# UNITED STATES PATENT AND TRADEMARK OFFICE

APPLICATION NO.	FILING DATE	FIRST NAMED INVENTOR	ATTORNEY DOCKET NO.	CONFIRMATION NO.
10/698,682	10/31/2003	Greg Franke	200315010-1	3560
22879	7590	06/21/2006	EXAMINER	
HEWLETT PACKARD COMPANY P O BOX 272400, 3404 E. HARMONY ROAD INTELLECTUAL PROPERTY ADMINISTRATION FORT COLLINS, CO 80527-2400			BROUSSARD, COREY M	
			ART UNIT	PAPER NUMBER
			2835

**Office Action Summary**

## **DETAILED ACTION**

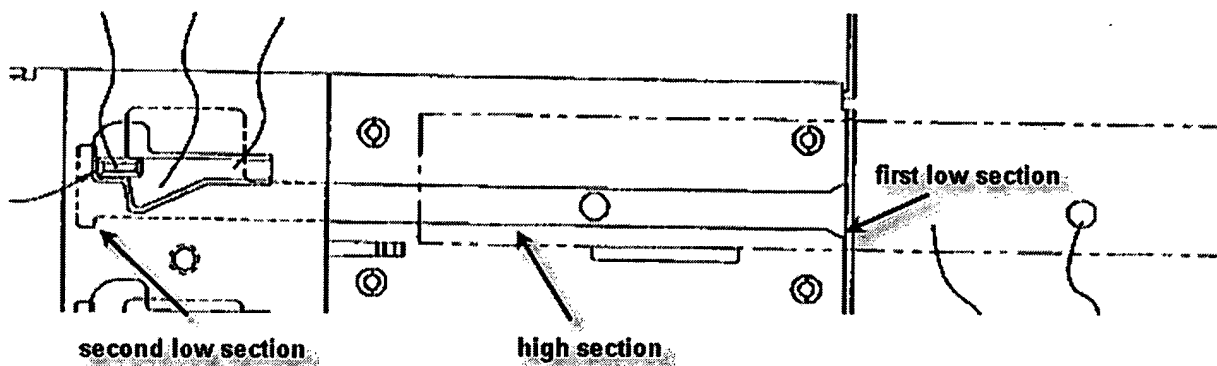
4. Claims 1, 4-6, 18, and 20 are rejected under 35 U.S.C. 102(e) as being anticipated by Chang (PN 6,373,694). With respect to claim 1, Chang teaches a media drive cage, comprising: a first slot (42) defined by top and bottom bearing surfaces and

having an opening and a termination (see Fig. 3), configured to receive a first protrusion (62) of a media drive (6), and defining a plane of movement for the first protrusion as it travels along a path through the first slot from the opening to the termination; and a first spring (54) disposed adjacent to the termination and operable to engage the first protrusion before it reaches the termination (see Fig. 5); wherein the first slot comprises first and second low sections at the opening and the termination, respectively, and a high section between the low sections (see Fig. 4 below),

the bottom bearing surface in the low sections defining a first height and the bottom bearing surface in the high section defining a second height higher than the first height.
